British Gas' comments on the joint SMER produced by the two ITE's.

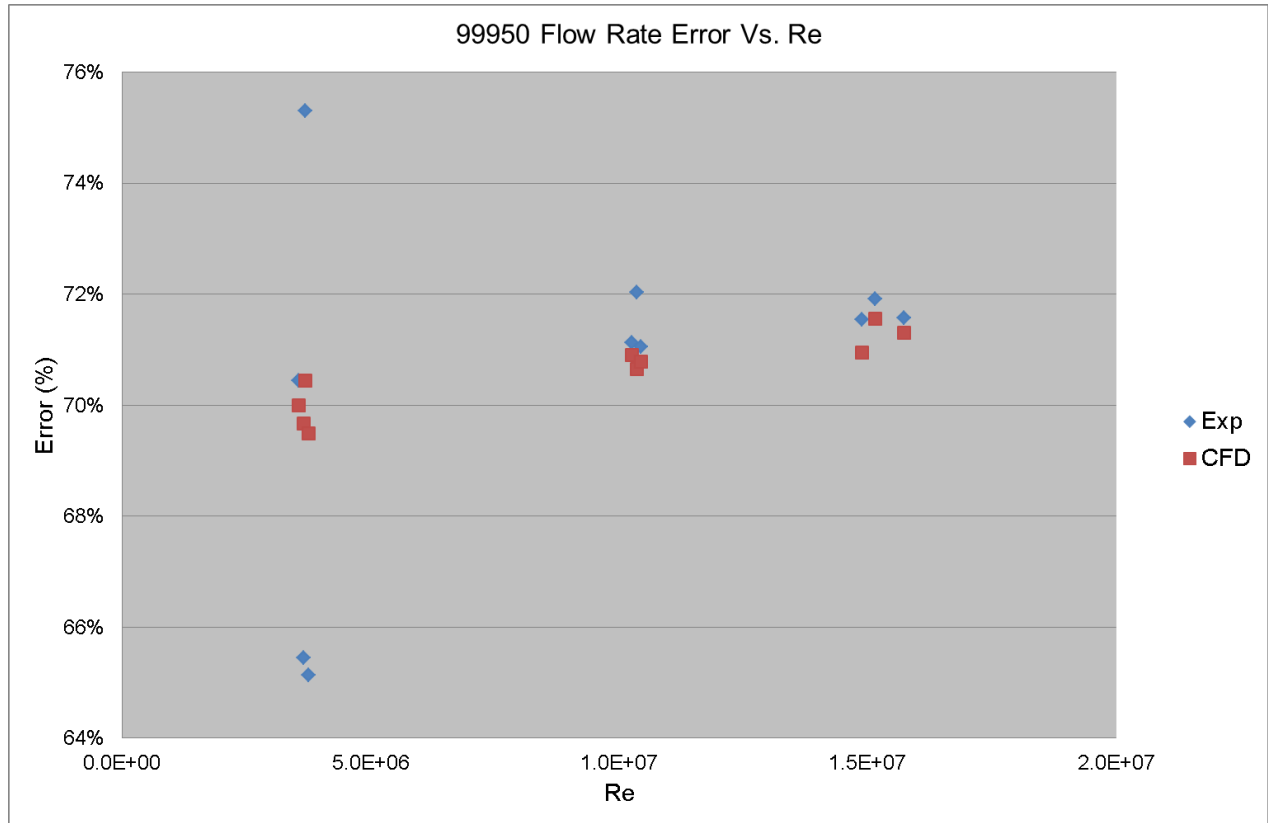
4. In figures 5 and 7 it would be useful to include all of the low flow rate data included including the rejected test points if they are not already included (not stated in the description).

Figure 7 does not show the excluded test results but has been repeated below including all test results. The outliers are clearly visible.
